MEMORANDUM

Subject: Clifton Boat Dock
Case Number SP-04-0081DS

A request has been received from Glen Clifton to construct a boat dock at 3117 1/2 Brass Buttons Trail.

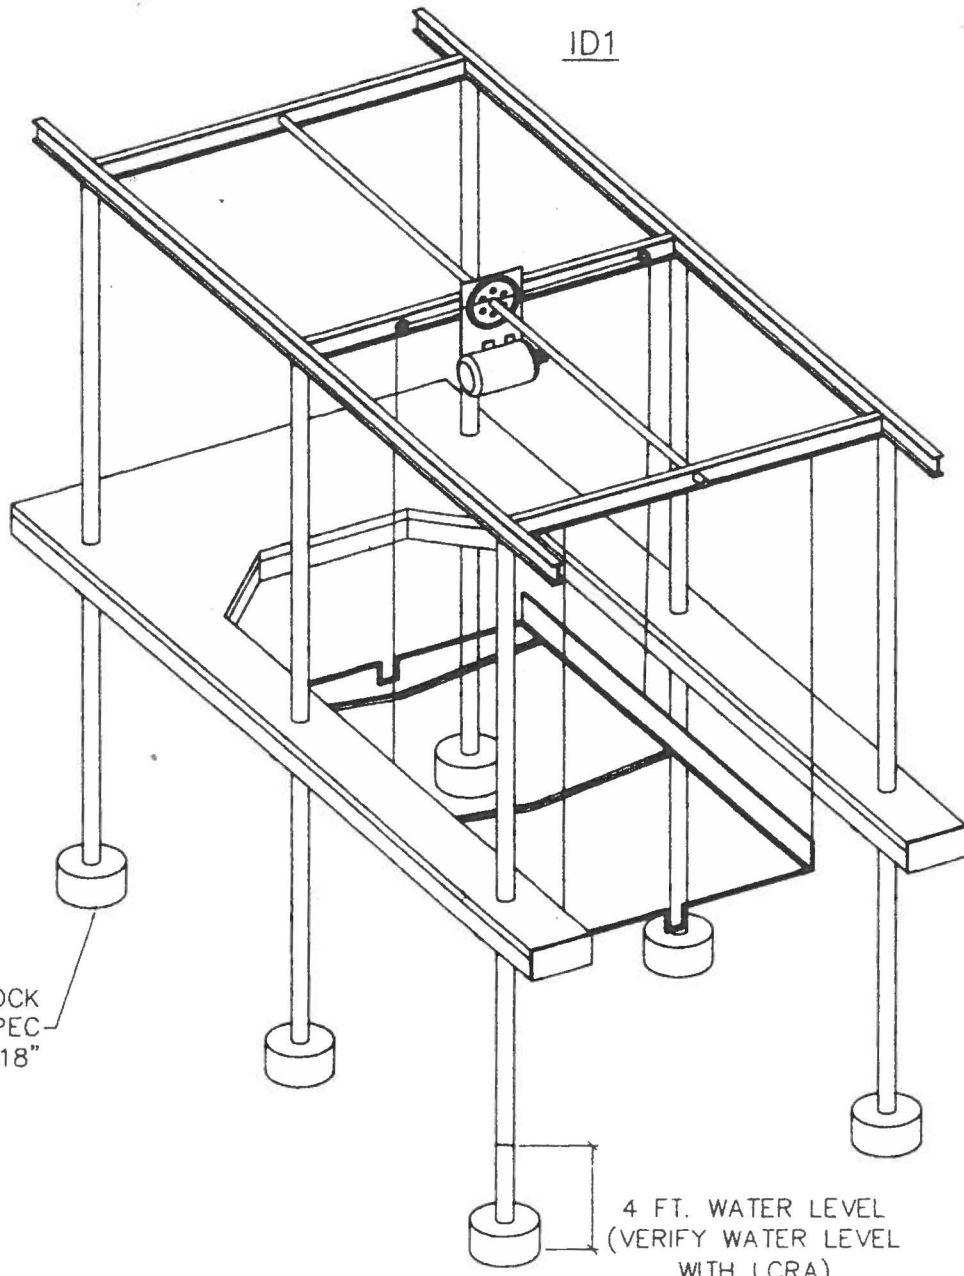
The Parks and Recreation Department staff has reviewed plans for the proposed project and finds they do not meet the requirements of Article XIII, Section 25-2-1176, (Regulations for the Construction of Boat Docks) of the Land Development Code. The proposed dock exceeds 20 percent of the shoreline width. The lot on which the dock is to be constructed has a shoreline width of 60 feet, allowing for a dock width of 12 feet. The proposed dock width is 14 feet 8 inches, covering 24 percent of the shoreline.

We request that you kindly grant us exemption from the 12 feet maximum width on the above proposed boat dock. Our drawings, which are in your possession, reflect a total width of 14ft 8 inches.

Parks and Recreation Board approval is required for structures greater than 20 percent of the shoreline.
